10 SUB2015-00143

GARY SOUTOULLO SUBDIVISION

GARY SOUTOULLA SUBDIVISION

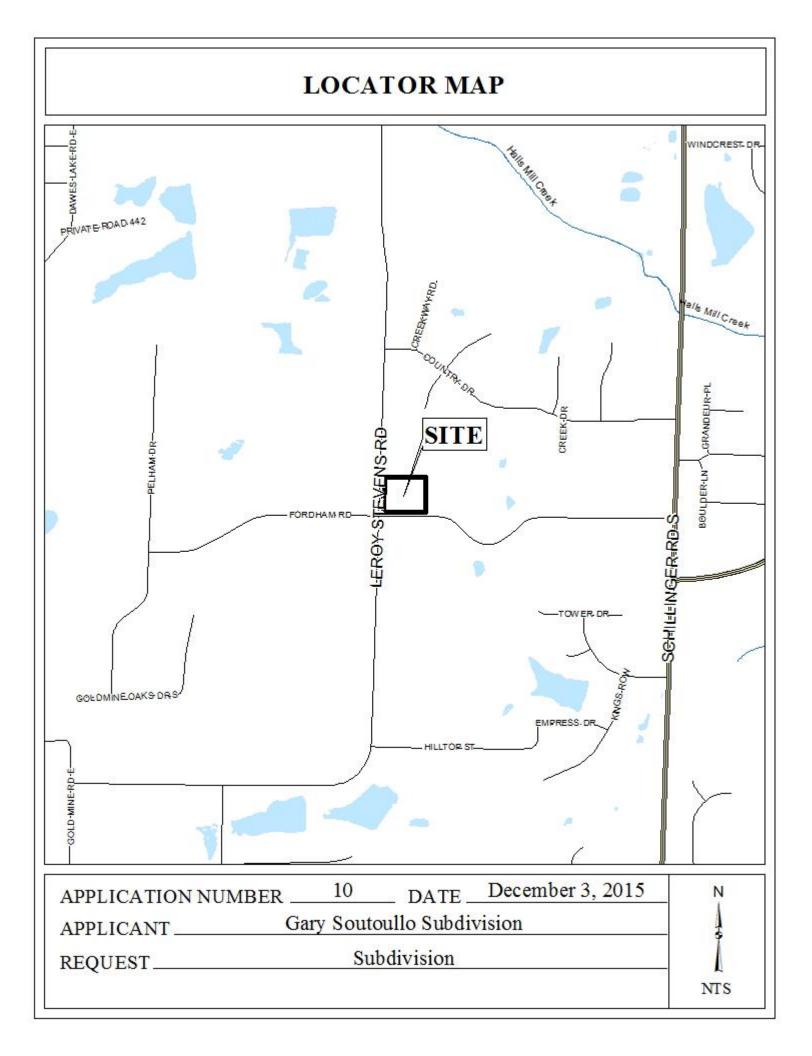
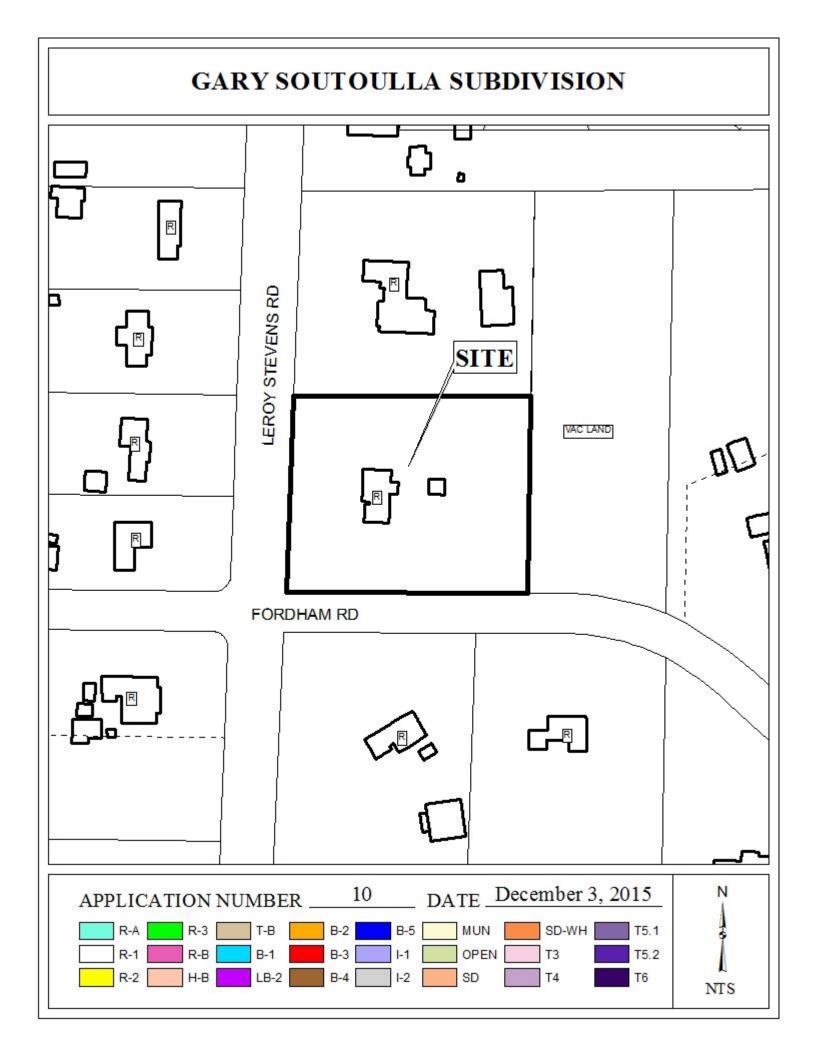
The proposed lot fronts both Leroy Stevens Road and Fordham Road. Leroy Stevens Road is a minor street that requires an 80' wide right-of-way width. The existing right-of-way width is depicted as 80' on the preliminary plat and should be retained on the Final Plat, if approved. Fordham Road, a paved minor street without curb and gutter, requires a 60' right-of-way width. The existing right-of-way width is depicted as 60' on the preliminary plat and should be retained on the Final Plat, if approved.

In accordance with Section V.D.2. of the Subdivision Regulations, the proposed lot appears to exceed the 15,000 square foot minimum lot size requirements for lots served by public water and private sanitary sewer systems. The lot size information is depicted in both square feet and in acres on the preliminary plat and should be retained on the Final Plat, if approved.

The 25-foot minimum building setback line is depicted on the preliminary plat and should be retained on the Final Plat, if approved.

The plat depicts dedication of a corner radius at the intersection of Leroy Stevens Road and Fordham Road in compliance with Section V.D.6. of the Subdivision Regulations. The dedicated corner radius should be retained on the Final Plat if approved.

As a means of access management, a note should be placed on the Final Plat, if approved, stating that Lot 1 is limited to one curb cut to Leroy Stevens Road and that Lot 2 and Lot 3 are limited to 1 curb-cut each to Fordham Road, with the size, design and location of the new curb-cut to be approved by Mobile County Engineering and conform to AASHTO standards.

This site is located in the County; therefore, any lots which are developed commercially and adjoin residentially developed property must provide a buffer, in compliance with Section V.A.8. of the Subdivision Regulations. A note should be placed on the Final Plat, if approved.

- 1) Retention of the existing 80' right-of-way width along Leroy Stevens Road;
- 2) Retention of the existing 60' right-of-way width along Fordham Road;

- 3) Retention of the 25-foot minimum building setback line on the Final Plat;
- 4) Dedication of the corner radius at the intersection of Leroy Stevens Road and Fordham Road in compliance with Section V.D.6. of the Subdivision Regulations, as shown on the preliminary plat;

- 5) Retention of the lot size information on the Final Plat;
- 6) Placement of a note on the Final Plat stating that the proposed Lot 1 is limited to one curb cut to Leroy Stevens Road and that Lot 2 and Lot 3 are limited to 1 curb-cut each to Fordham Road, with the size, design and location of the new curb-cut to be approved by Mobile County Engineering and conform to AASHTO standards;

- 7) Placement of a note on the Final Plat stating this site is located in the County, and therefore any lots which are developed commercially and adjoin residentially developed property must provide a buffer, in compliance with Section V.A.8. of the Subdivision Regulations;
